Southern California Edison Company

Subject: Docket Nos. 50-361 and 50-362
San Onofre Nuclear Generating Station, Units 2 and 3

ATTACHMENT I

EVALUATION
OF
POST-WELD HEAT TREATMENT PROCESSES

Figure C-1. POSTWELD HEAT TREATMENT VERTICAL CONFIGURATION TO DETERMINE ID TEMPERATURES - 3-3/8" THICK MATERIAL

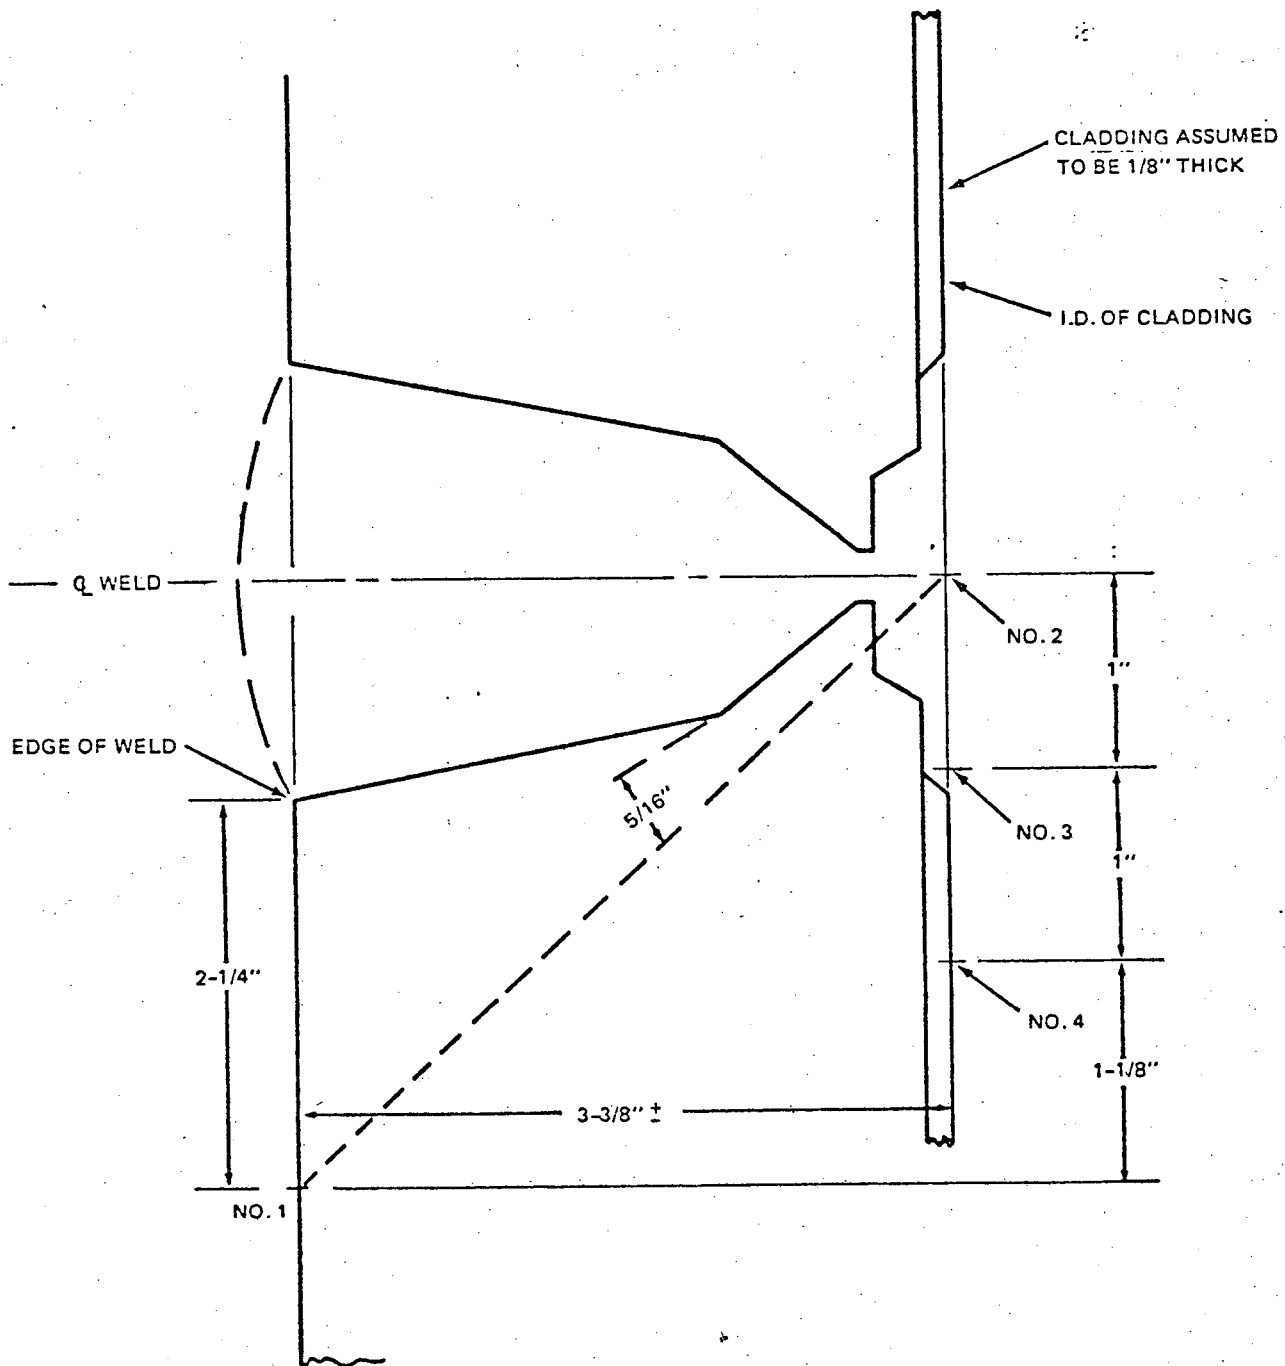
Contrary to the above, as of February 5, 1979, the post weld heat treating procedure using the quartz lamp technique had not been qualified before use to demonstrate that the minimum heat treating temperature of 1100°F, a design requirement, was met during the post weld heat treatment of main steam piping and reactor coolant piping welds. This procedure had been used since mid-1977 for heat treating the aforementioned welds at Units 2 and 3.

The first test was run on a vertical reactor coolant system cold leg elbow to elbow weld with a 3-3/8 inch wall thickness (figure C-1). This test was selected since it would yield the largest negative through-wall differential temperatures since "chimney effect" (air velocity gradients in the

pipe due to thermal heating) is maximized in vertical piping configurations. Reference thermocouples were placed on the outside diameter of the pipe at the crotch and outside of the elbow (location 1) 2-1/4 inches from the lower edge of the weld. These locations correspond to the standard thermocouple locations on production welds. Eight test thermocouples were then attached to the pipe. Two thermocouples were placed on the outside diameter of the elbow adjacent to the reference thermocouples described above. The remaining six thermocouples were placed on the inside diameter of the elbow at locations 2, 3, and 4 (figure C-1) on the crotch and outside of the elbow. The data recorded by one of the eight thermocouples, No. 4, located on the outside elbow was not accurate. Subsequent to the test, when the thermocouple was inspected, it was found to be held in place by the insulation and was not properly welded to the elbow wall which explains the inconsistent reading.

The thermocouple locations are shown in figure C-1 and the temperatures recorded are listed in table C-1. The through-wall differential temperature was 25F on the crotch of the elbow and 40F on the outside of the elbow one inch away from the weld centerline. This is well outside the heat affected zone.

The conclusion that can be drawn from this test is that for all pipe with 3-3/8 inch or less wall thickness, as long as the reference thermocouple is 40F or better above the code required minimum temperature, the inside diameter heat affected zone temperature will be acceptable. Since a vertical pipe configuration was tested and since this configuration maximizes the through-wall gradient, all horizontal pipes 3-3/8 inch or less in thickness will also have inside diameter heat affected zone temperatures that are acceptable as long as the reference thermocouple is 40F above the code required minimum temperature.
